INDESIT company

Model type:
MTB241

Commercial code:
F028992

5172080 Exploded views

0521123: SEALS FOR DOORS FOAMED AS ONE PIECE

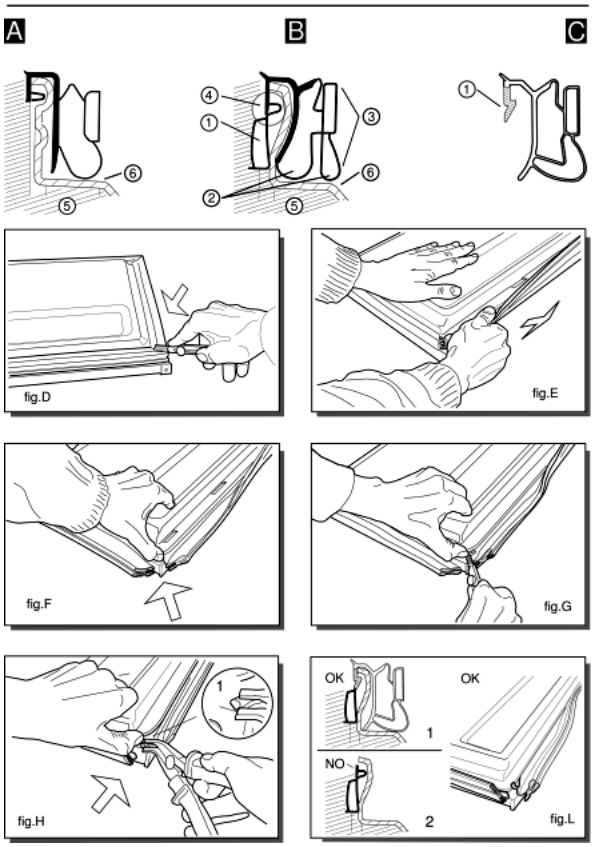
Various types of gaskets with different profile, as shown in figures (A) and (B), are used to fix the door (fig. A-5; B-5) and the inner door (fig. A-6; B-6) on the block foamed doors of combined freezers and refrigerators.
---Ilpea profile 245; 179; 412 (fig.A)
---Ilpea profile 287 (fig.B)
When replacing gaskets with profiles 245; 179; 412 these are fixed with screws (2 per corner) to the door.
Gaskets with profile 287 can not be used as spare parts but are designed to house the Ilpea type 900 gaskets (see figure C).
When replacing the gasket (287), once it is removed you will find a pocket (fig. B-1) between the door and inner door.
The rigid tooth (fig.C-1) of the gasket (900) is inserted inside between the pocket and the inner door, doing away with the need for screws.
Gasket with profile 287 is easy to identify since it has an exterior double edge (fig.B-2) which acts as a cushion when the door is closed.

To replace this gasket, follow these steps:
---Dismount the door and cut the four corners of the gasket along the joint (fig.D);
---lift the gasket and pull it carefully along its full length without tearing it (fig.E).
The purpose here is to detach the inner door slightly from the foam along the exterior edge for a depth equal to that of the gasket (fig.B-3);
---lift the corner of the inner door slightly, prising it up with your thumb (fig.F). Do not use a tool which might break the inner door;
---continue cutting the gasket inside the inner door for about 6 mm (fig.G);
---push in the tip of the pliers (type USAG N131) and pull outwards until you see the top edge of the pocket (fig. B-4) which is empty (fig.H-1);
---if you carry out this operation correctly (fig.L) you will be able to pull off the top edge of the pocket for the full length of the door.
If the gasket tears before the top edge (fig. L-2) you should repeat this operation from the other corner of the door.

---once the gasket (287), has been removed the space above the pocket (fig. L-1) can house the rigid tooth (fig. C-1) of the gasket 900.
When you fit this gasket ensure that it lies flush against the edge for the full length of the door.
If the rigid tooth is difficult to fit, eliminate any residues of foam between the door and the inner door in the gasket area.
fig.5131549A

N1025158FIG1

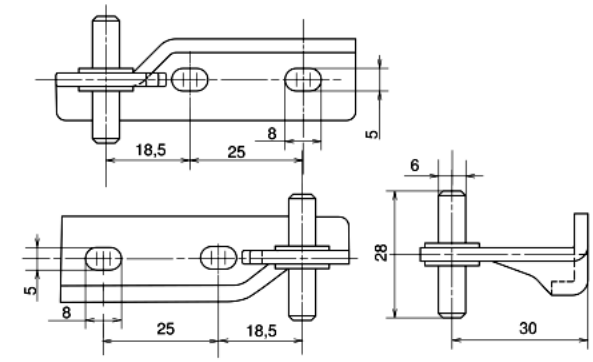
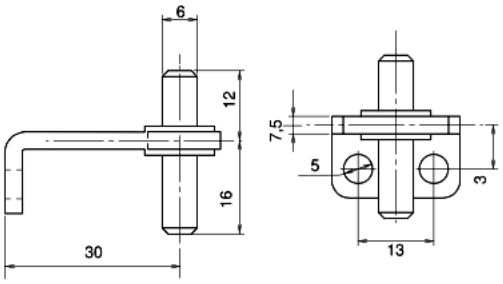
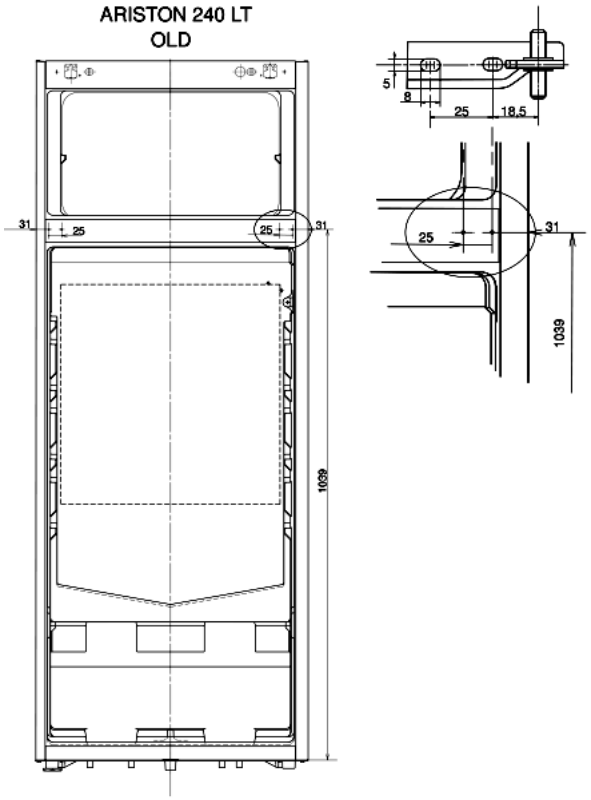
n1025158: New central hinge for Ariston-55 2-door 240 litre refrigerators (Carinaro).

From serial no. 60123.0001, the Carinaro factory has modified the body of 240 litre refrigerators by introducing a new central hinge (see figure N1025058 Fig.1) attached to the side panel.
This hinge is still reversible but cannot be fitted on premodification models where the hinge was attached to the central trim of the refrigerator body (see Figure N1025058fig2).
When changing the door opening from right to left, the new hinge does not need to be inverted like the previous one, just moved to the left side.
To secure it, a hole must be made on the left side of the refrigerator body (see figure N1025058fig3).

141794 - POLAR WHITE CENTRAL HINGE (CARINARO)
142756 - POLAR WHITE CENTRAL HINGE (MANISA)
142756 - CHROME-PLATED CENTRAL HINGE

053838 - CHROME-PLATED CENTRAL HINGE
053478 - WHITE CENTRAL HINGE
114624 - POLAR WHITE CENTRAL HINGE

OLD 053838 - 053478 - 114624

NEW 141794 - 142760 - 142756
